- AltaLink
- CanREA
- Capital Power
- Direct Energy
- Energy Storage Canada
- Enmax [Posted: Nov. 25, 2020]
- Greengate Energy
- TCE
- TransAlta
- Turning Point Generation
- UCA
- Summary of stakeholder feedback and AESO response [Posted: Dec. 7, 2020]

# Stakeholder Comment Matrix – Oct. 1, 2020

Request for Feedback on *Long-term Energy Storage Market Participation Options Paper*

Figure 1: Co-located technologies configured as independent assets (based on the ½ range participation model)

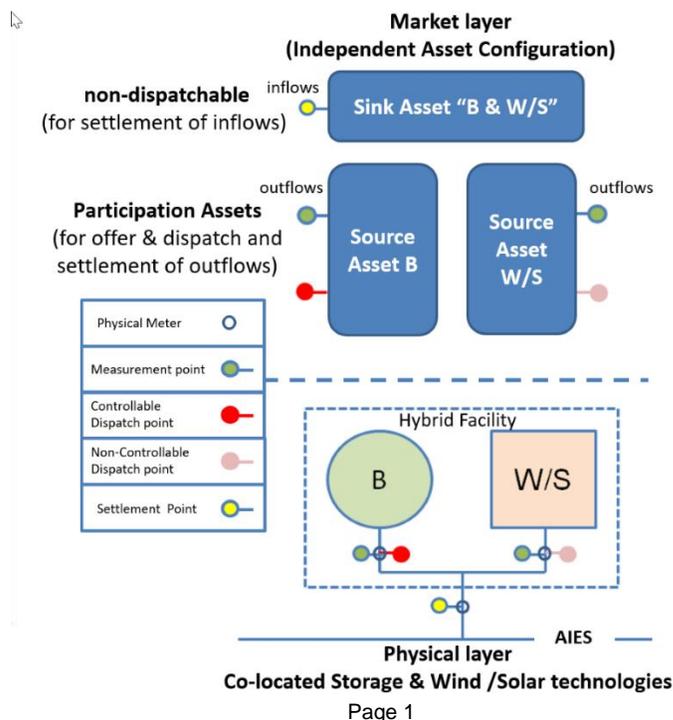
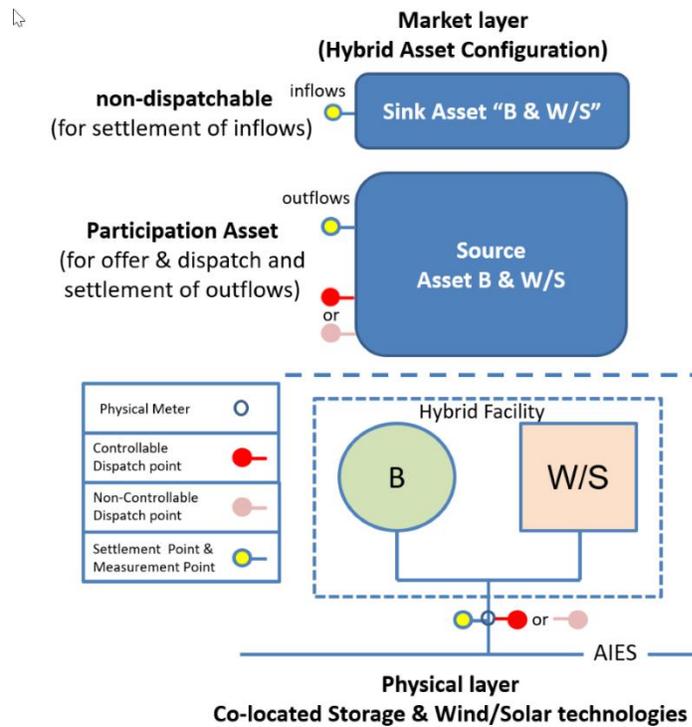
Based on the feedback received from numerous stakeholders, there remains some confusion as to the differences between a hybrid asset and a hybrid facility/site. In order to prevent further confusion, the term “co-located technologies” will be used to describe the nature of the actual physical equipment installed on a customer site. Storage co-located with solar or wind will be defined as co-located VER+ES.

As illustrated in the figures above, co-located technologies are defined as multiple technologies that are located on the same site behind a single point of connection. These co-located technologies may be configured such that each technology is operated as an independent asset in the energy market, as in *Figure 1*. Co-located technologies may also be configured as a single hybrid asset when the pool participant chooses to operate the multiple technologies co-located on the same site as a single entity within the energy market, as shown in *Figure 2*. The choice of market asset configuration (hybrid or independent) depends on what makes the most sense for the operation of the asset. A pool participant should consider the following before choosing the market asset configuration:

- 2) Metering determines how Demand Transmission Service (DTS) will be assessed, not the asset configuration. An independent asset configuration for co-located technologies, as shown in figure 1, may require additional metering in order to receive the same DTS treatment as the hybrid asset configuration for the same site.
